## SCHEDULE A: Applications with Recommendation

**Appn Ref No:**  
22/0760

**Location:** Croft Villa, Wetheral, Carlisle, CA4 8JQ

**Proposal:** Retention Of Existing Access; Erection Of Boundary Walls Together With Formation Of Vehicular Access To Rear Of Property (Part Retrospective)

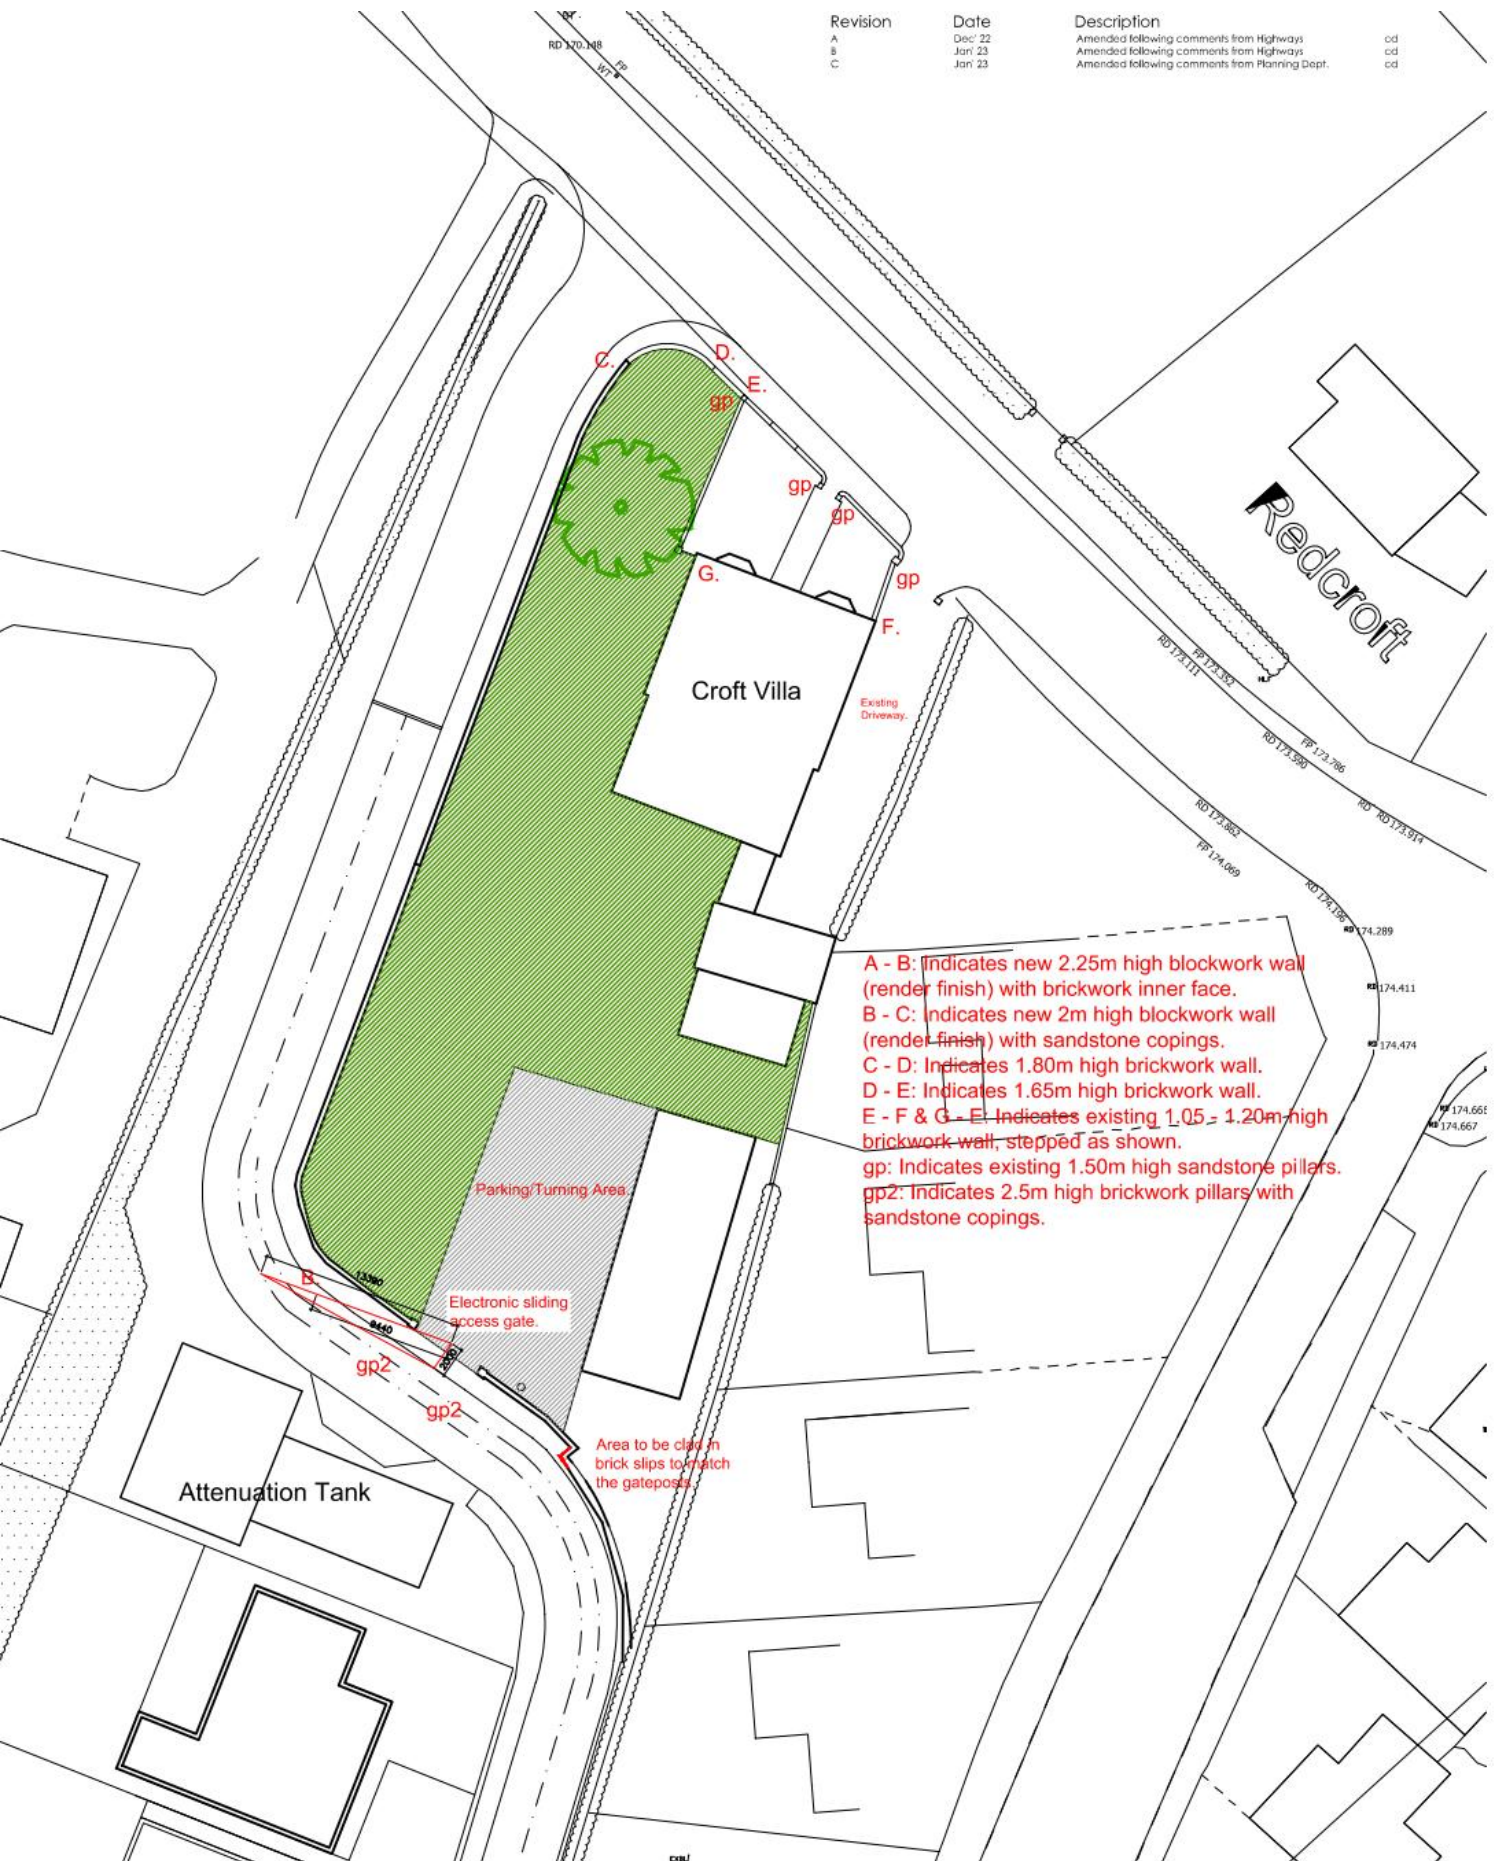
stark. The committee does not object to the application, but would support the addition of brick slips to break up the wall and improve the overall appearance. The intention of the applicants to plant trees behind the wall is welcomed.

of render is broken up by the existing brick pillar adjacent to the rear access and the proposed area where the boundary treatment 'dog legs' which is to be clad in brick slips to match the existing brick gate posts (as shown on the submitted block plan). In such a context it is not considered that the proposal would have a sufficient adverse impact upon the visual amenity of the surrounding area to warrant refusal of the application on this basis.

- 6.11 In order to protect the visual amenity of the area it is suggested that Members impose a relevant condition within the decision notice, should they approve the application, ensuring that the additional area of wall to be clad in brick slips as shown on Drawing No.22-41-02 Rev C is undertaken within 3 months of the granting of planning permission.

2. The additional area to be clad in brick slips to match the existing gateposts as shown on Drawing No.22-41-02 Rev C shall be completed within 3 months of the date of this planning permission.

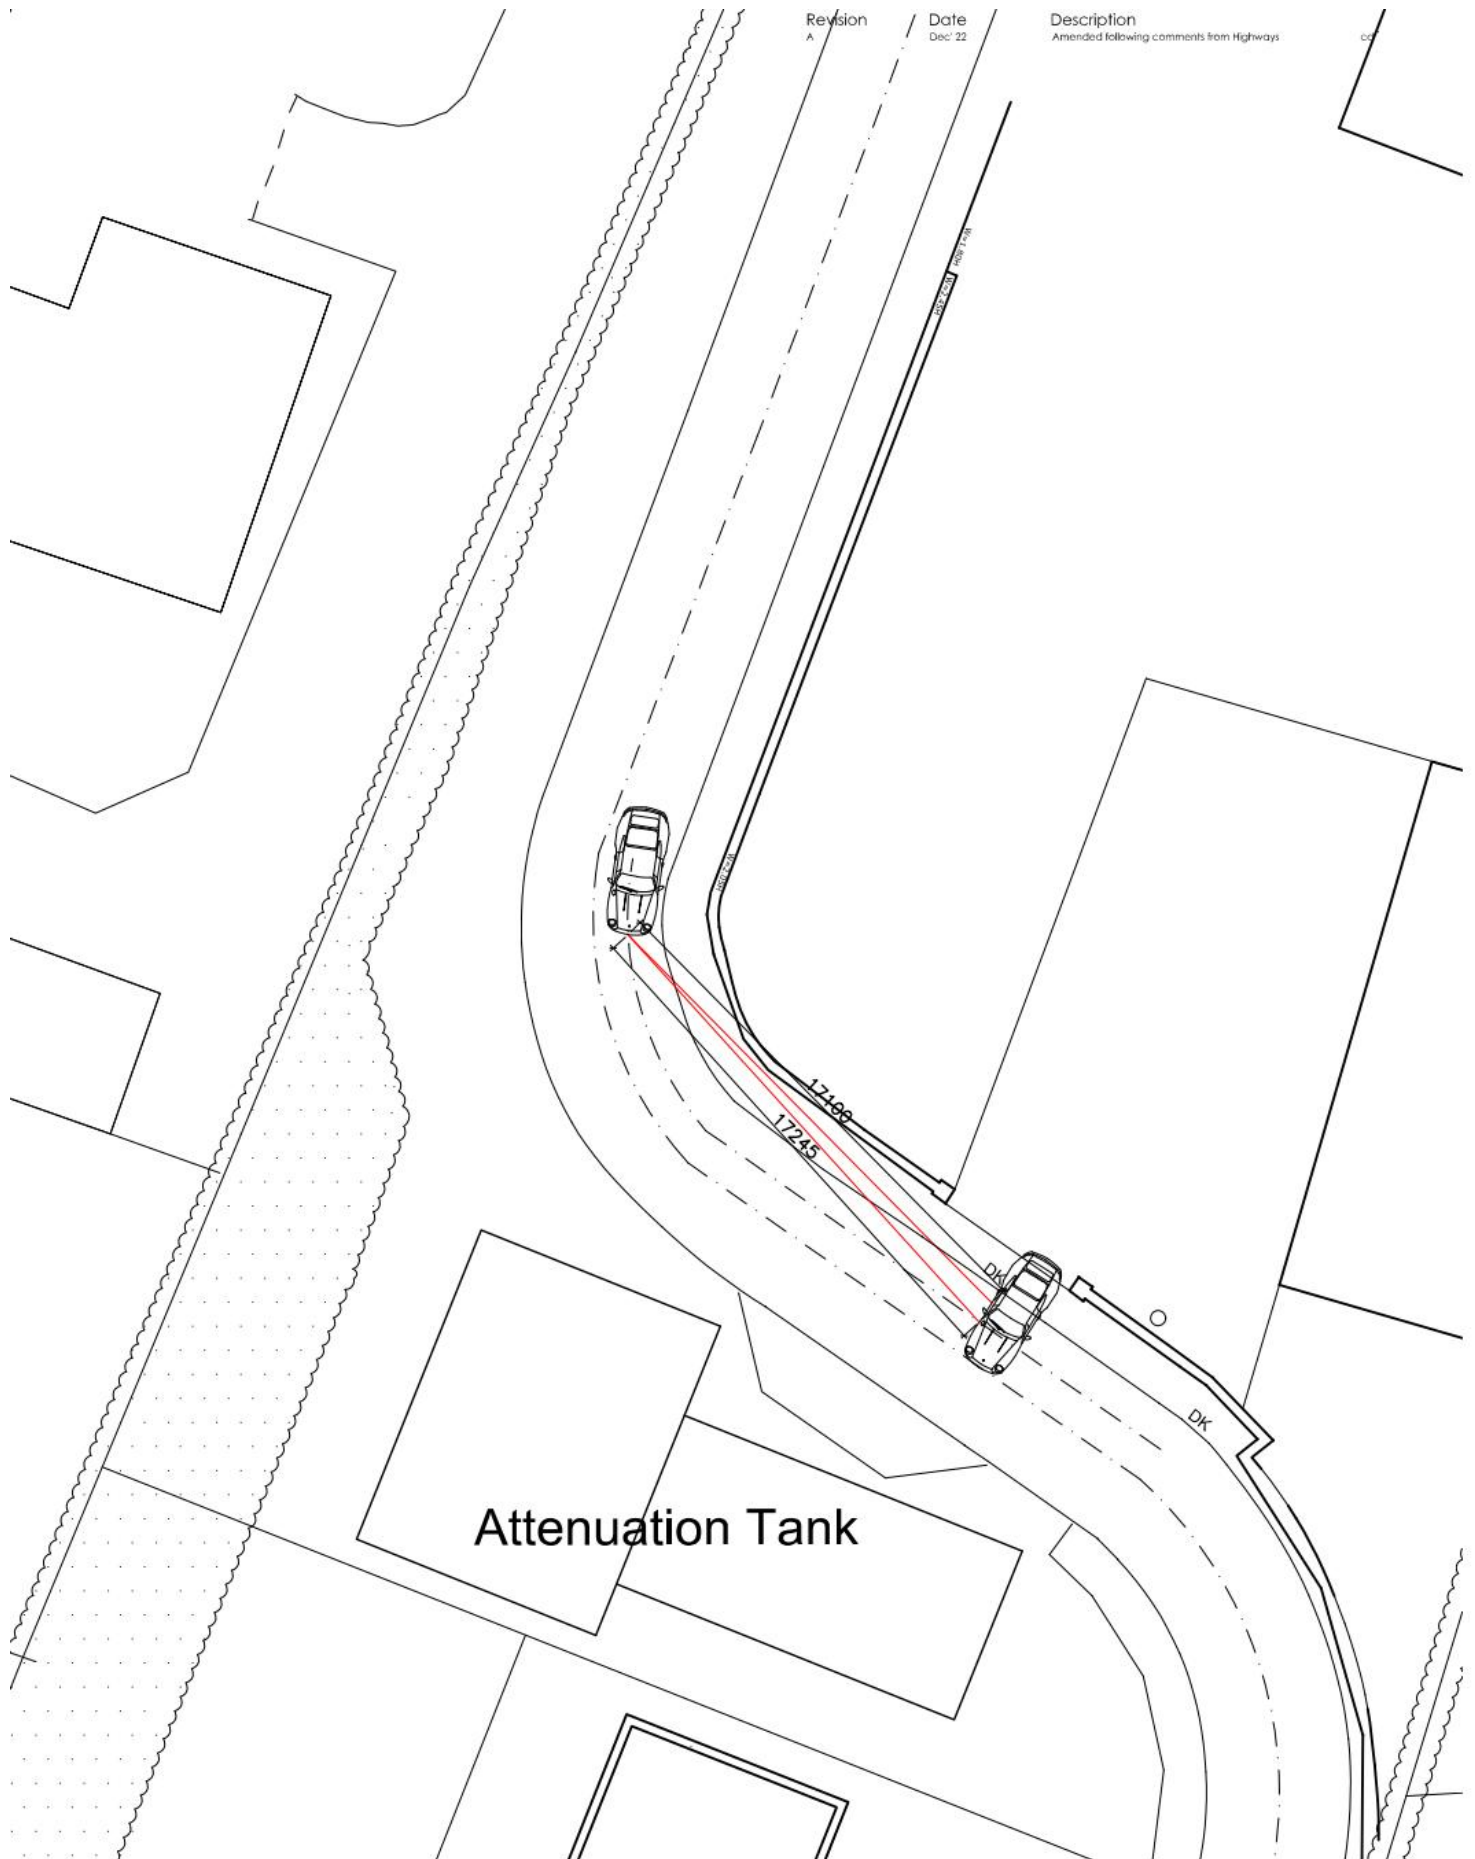
Drawing no RD 170.148 (c) shows splays considered acceptable for the very slow speeds on the road. It is also considered that the access allows for the required pedestrian visibility splay. In light of the above the Local Highway Authority has no objection to this application.

consideration the proposed boundary treatment as well as visibility splays which are achievable for vehicles coming round the bend. Cumbria Highways have considered this information and have not raised any objections regarding the visibility splays shown concluding that the development will not have an 'unacceptable impact on highway safety'. In such circumstances the proposal is compliant with the objectives of the NPPF and policy IP2 of the CDLP with regard to impact upon highway safety.
